Proposed Technical Specifications Changes

New York Power Authority
Indian Point 3 Nuclear Power Plant
Docket No. 50-286

Safety Evaluation of Proposed
Technical Specifications

Figure 3.10-2 Hot Channel Factor Normalized Operating Envelope

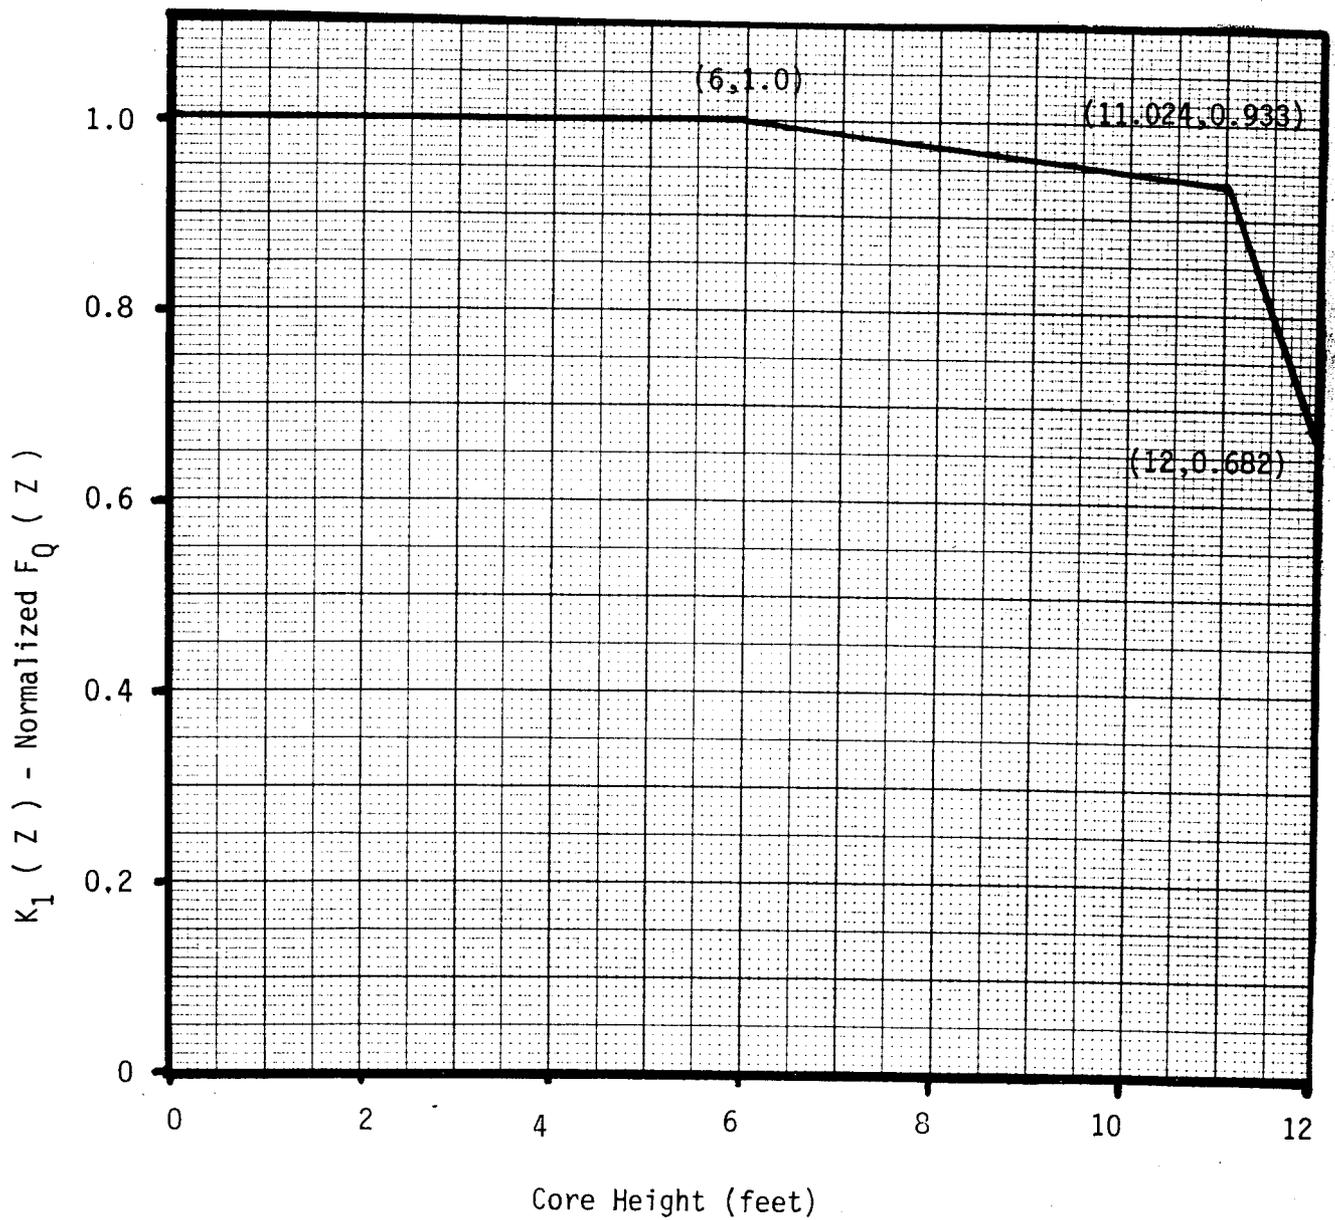
This application supplements the proposed Technical Specifications revision transmitted by Reference 1 by revising Figure 3.10-2 to reflect the proposed F_Q limit of 2.20. Figure 3.10-2 provides the normalized $K(z)$ values as a function of core height. The $K(z)$ curve is generated by normalizing the $F_Q(z)$ curve to the maximum F_Q value.

The above describes the affect of revising the maximum F_Q limit to 2.20 on $F_Q(z)$ curve. In order to revise the $K(z)$ curve to reflect this change in the maximum F_Q limit, the revised $F_Q(z)$ curve must be normalized to a maximum F_Q limit of 2.20. As shown in Figure 2, the first line segment of the revised $K(z)$ curve will have a constant value of 1 through the bottom half of the core. The origin of the second line segment of revised $K(z)$ curve is at the point which corresponds to a core height of 6 feet and a $K(z)$ of 1. The endpoint of this second line segment is that point corresponding to a core height of 11.024 feet and a $K(z)$ value of 0.933. The $K(z)$ value of 0.933 is the normalization of the F_Q value of 2.0526 to a maximum F_Q of 2.20 ($2.0526/2.20 = 0.933$). The origin of the third line segment is the aforementioned point corresponding to a core height of 11.024 feet and a $K(z)$ value of 0.933. The endpoint of the third line segment is that point corresponding to a core height of 12 feet and a $K(z)$ value of 0.682. The $K(z)$ value of 0.682 is the normalization of the F_Q value of 1.5 to a maximum F_Q of 2.20 ($1.5/2.20 = 0.682$).

COMPARISON OF $F_Q(Z)$ AND $K(Z)$

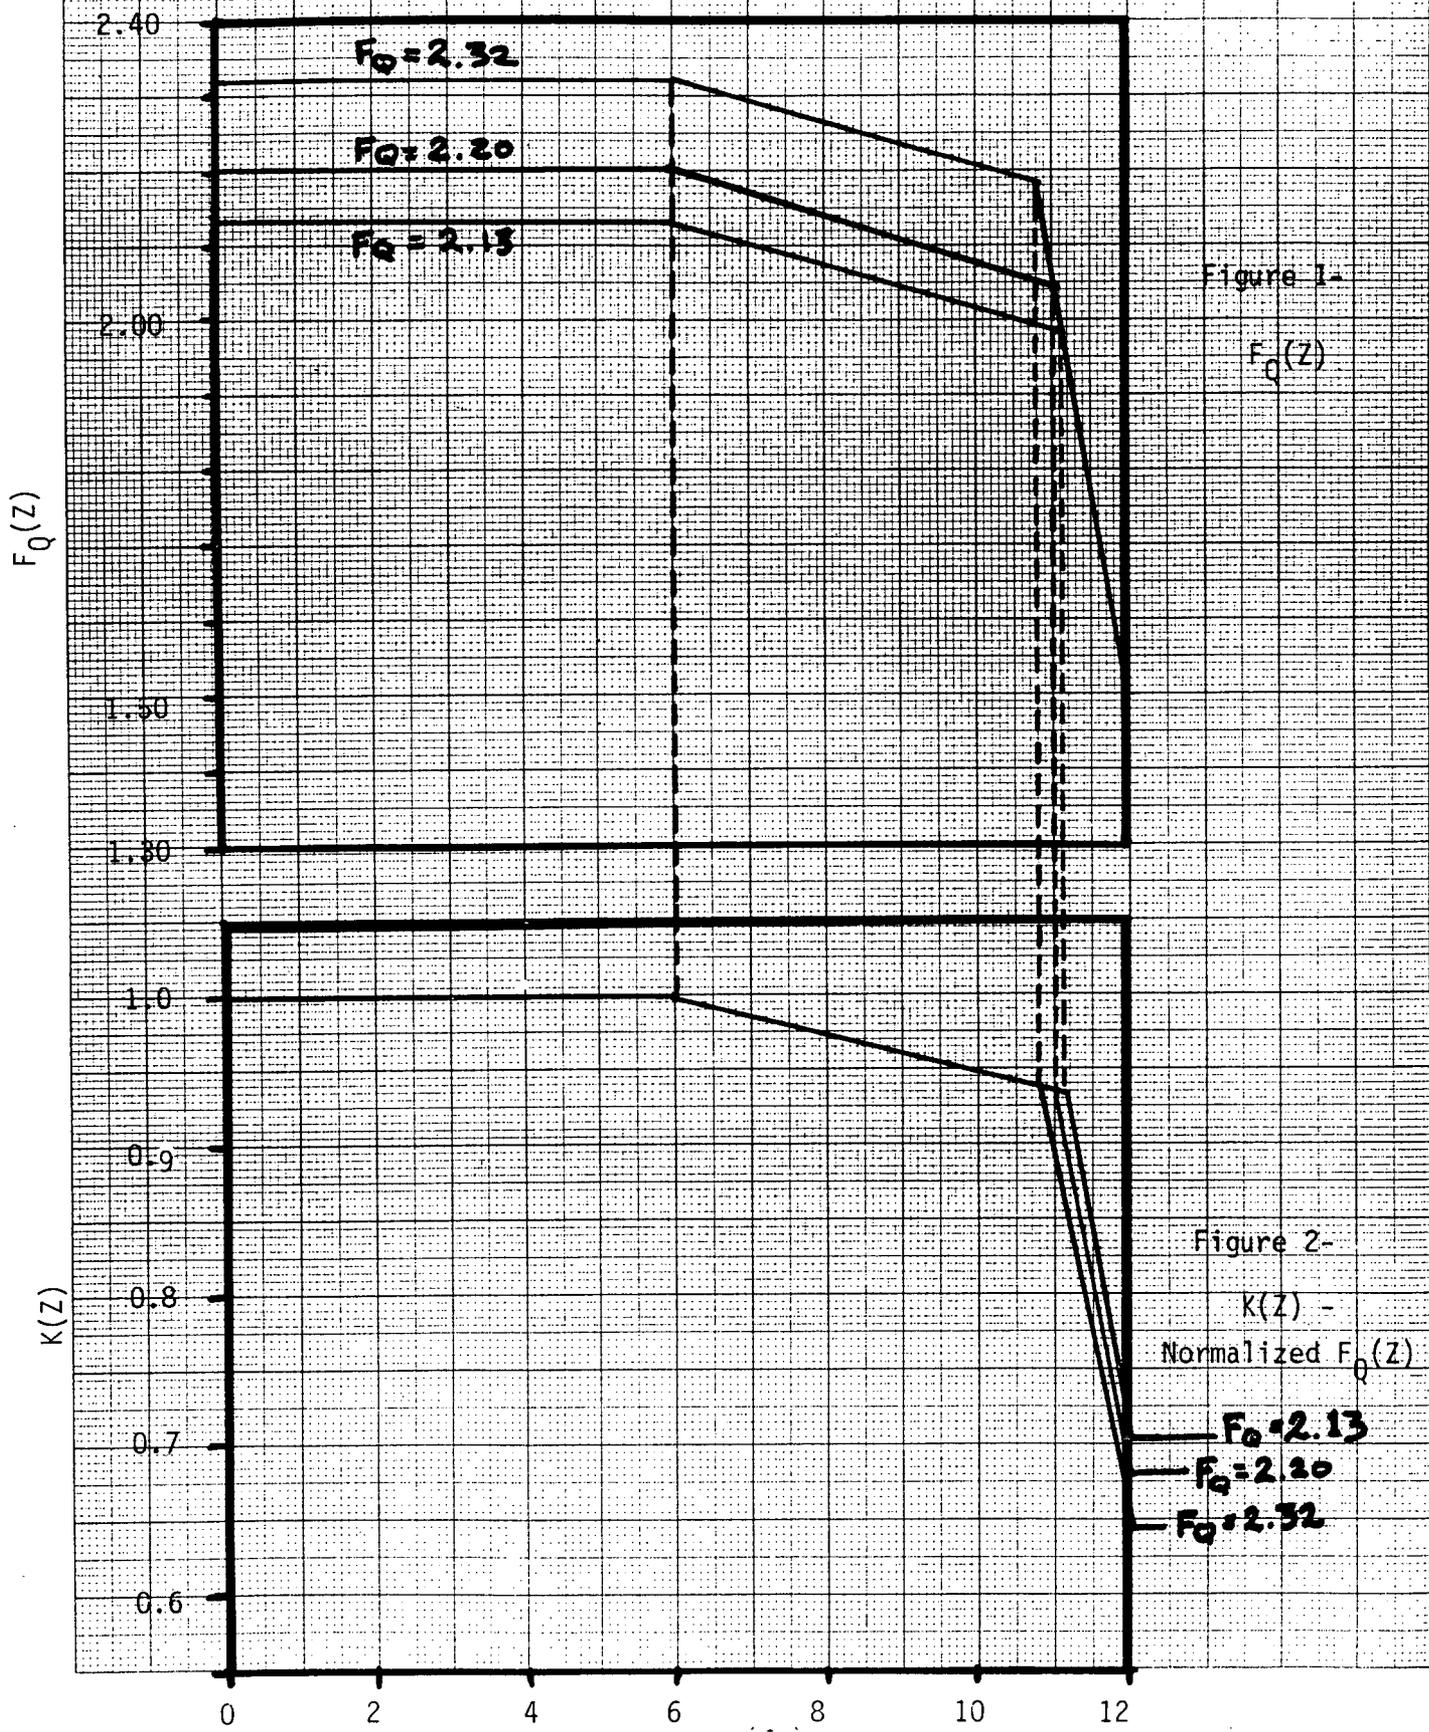
As can be seen in Figure 1, the $F_Q(z)$ curve consists of three line segments. The first line segment of the $F_Q(z)$ curve (bottom 6 feet of the core) is determined by the maximum large break LOCA peaking factor which corresponds to the peak local power of the chopped cosine power shape, and is of constant value through the bottom half of the core. The second line segment is dictated by both the large and small break LOCA analyses. The third line segment is based on the limiting small break LOCA power shape. Both the $F_Q(z)$ endpoint and the slope of the third line segment are dictated by this shape. As this power shape has not changed, the slope of the third line segment and the $F_Q(z)$ endpoint have remained constant.

When the maximum F_Q is less than 2.32, the first line segment of the $F_Q(z)$ curve is lowered to the appropriate level commensurate with the large LOCA analysis. As shown in Figure 1 for the present case, the first line segment is lowered to a F_Q value of 2.20 and is of constant value through the bottom half of the core. To ensure the limitation of the small break LOCA power shape, the second line segment must begin at the end of the first line segment (6 foot) and must be parallel to the second line segment of the $F_Q(z)$ curve based on a maximum F_Q of 2.32. The endpoint of the second line segment of the $F_Q(z)$ curve is at the point where it intersects with the third line segment of the 2.32 $F_Q(z)$ curve. For the present case, the second line segment of the 2.20 $F_Q(z)$ curve will intersect the third line segment of the 2.32 $F_Q(z)$ curve at the point corresponding to a core height of 11.024 feet and a $F_Q(z)$ of 2.0526. This point is also the origin of the third line segment of the 2.20 $F_Q(z)$ curve. The small break LOCA power shape dictates the endpoint of the third line segment to be at a F_Q value of 1.5.
